Aqueous Solutions (owner) AQS-MFG-REMIN-AUX01
REMIN fabrication drawing AUX01 (AQS-PLAN-006 M3; graph Rev
Type: fabrication drawing (GA / nozzle orientation / part sheet) Rev eefdf923 Issued 2
Created: flow graph pipeline Approved: not approved (study)
Sheet 1 of 1 AQS-DWG-001

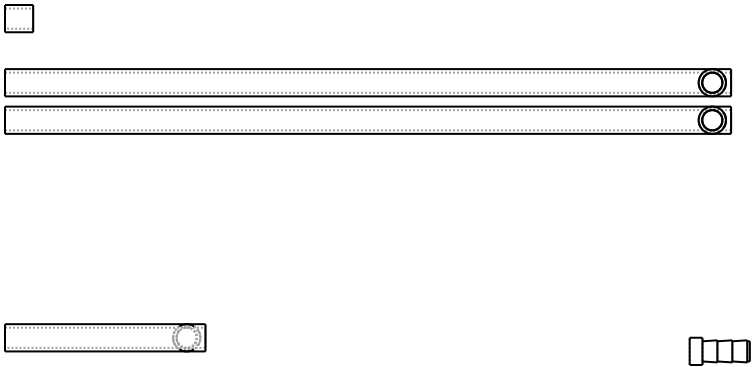
Graph revision AD - aux01: Connection hardware DN15 as open-bore tube (lib/dn Sch 40 table), flush at the envelope faces; atmospheric per duty section 4
Graph revision AD - aux01: Side connections ride tray risers; hose makeup by the connecting line at the face; the W4 110 percent rule draws no flange (no pro
Graph revision AD - aux01: N3 drain passes through the tray floor; N4 vent stands on the tank top head
